UNITED STATES PATENT AND TRADEMARK OFFICE

10/589,445

| Office Action Summary | Application No. 10/589,445 | Applicant(s) BEELE, JOHANNES ALFRED | |

DETAILED ACTION

**FIG. 3**

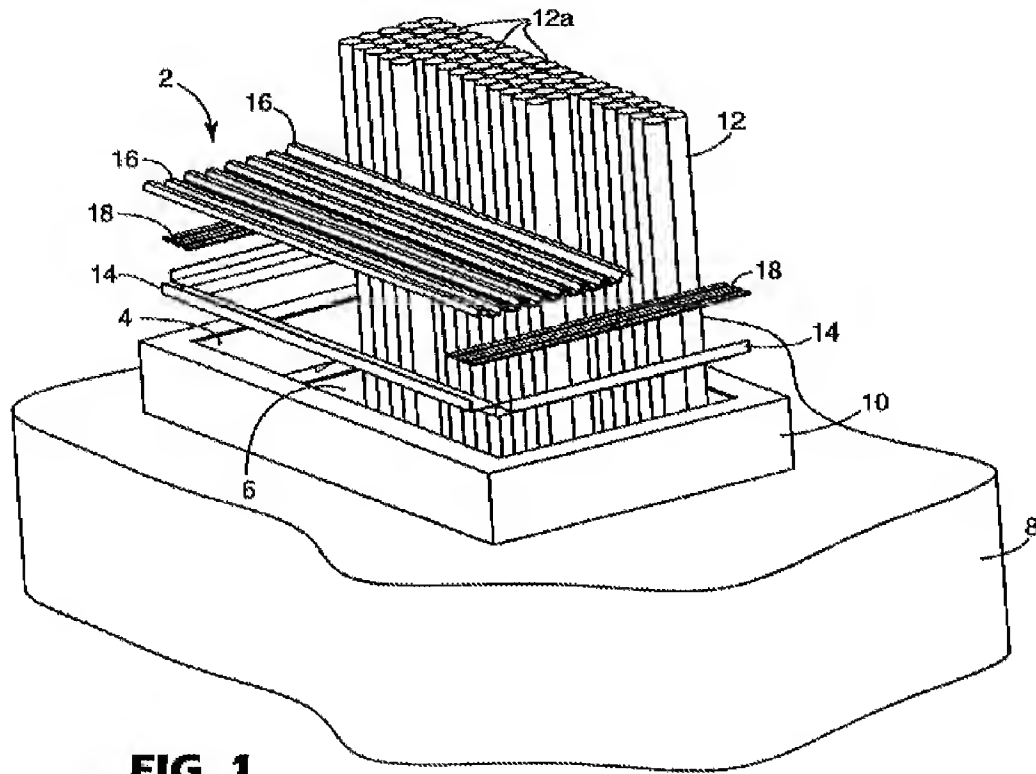
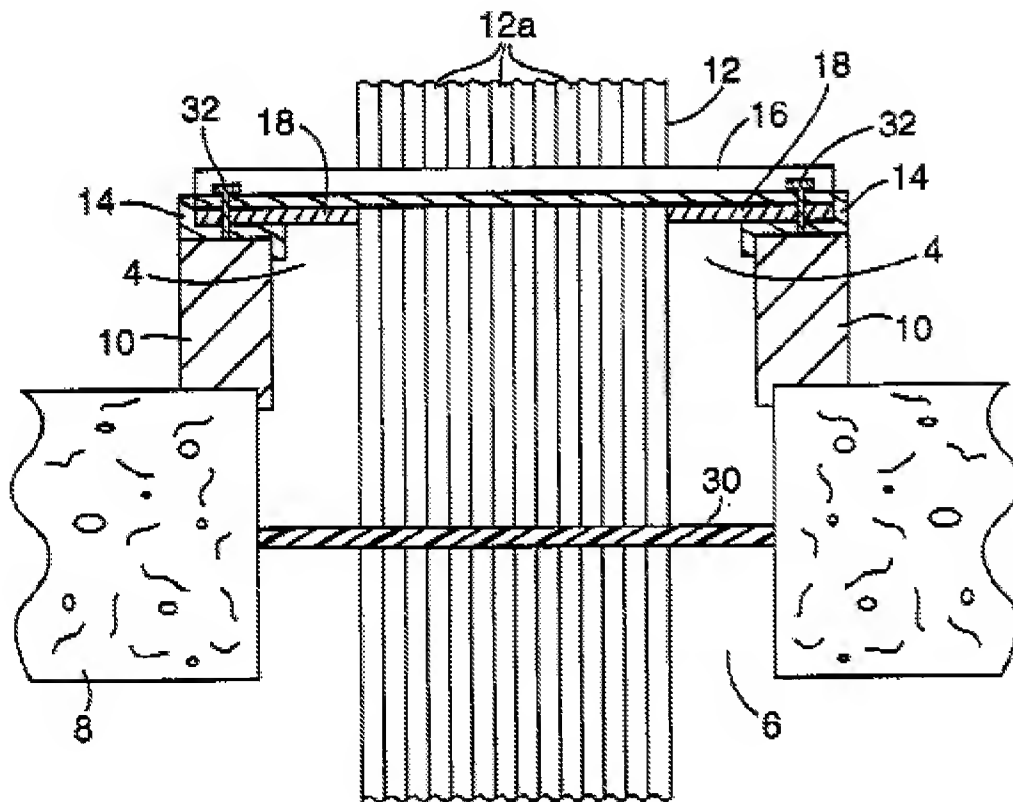
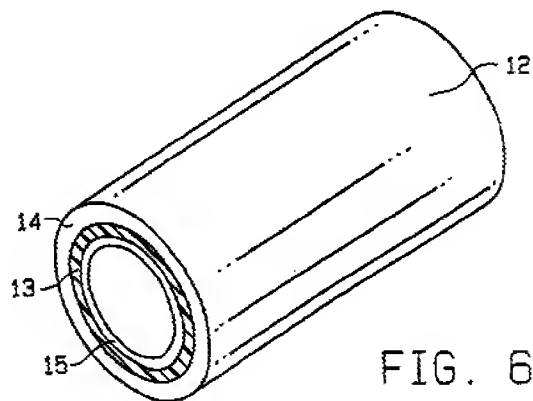
wall (See paras. 21-31, 34-38 and FIGs 1 and 3, cover assembly 2, with fire-resistant overlapping slats 16, side members 18, frame 14, riser 10 and stop material 30. See also the fire-resistant barrier material disclosed at para. 38.)

in which at least one transport device has been fed through, or will be fed through, each of the first and second parts being at least partly placeable in the opening (*See FIGs 1 and 3, bundle 12 of items 12a through opening 4 and the fire-resistant materials.*), the first parts being designed to at least partly envelop the transport device and the second parts being designed to be placed between the first parts and/or between the first parts and an inner wall of the opening to at least virtually completely seal the opening (*See FIGs 1 and 3 and para. 38 where all of the materials are within the opening.*), the first parts being substantially manufactured from a fire-resistant material (*See paras. 29-33 and 38.*), the second parts being manufactured from a fire-resistant material based on a

Regarding claim 5, Cordts ('814) teaches wherein at least one of the second parts is designed in the shape of a plate-shaped element or a beam-shaped element (*See FIGs 1 and 3.*).

Regarding claim 7, Cordts ('814) teaches wherein at least one of the first parts is sleeve-shaped and includes a slot to allow the at least one of the first parts to be placed around the transport device (*See FIGs 1 and 3. The claims do not describe the shape of the sleeve.*). Beele ('106) also teaches a sleeve (*See FIG-6, 12.*).

Regarding claim 8, Cordts ('814) teaches wherein the at least one of the first parts is constructed and arranged to allow longitudinal edges of the slot to permanently overlap each other under the influence of material stress (*See FIGs 1 and 3.*).

Regarding claim 9, Cordts ('814) teaches wherein at least two of the first parts are designed such that the at least two of the first parts can together form a sleeve that is placeable around the transport device (*See FIGs 1 and 3. The claims do not describe the shape of the sleeve.*). Beele ('106) also teaches a sleeve (*See FIG-6, 12.*).
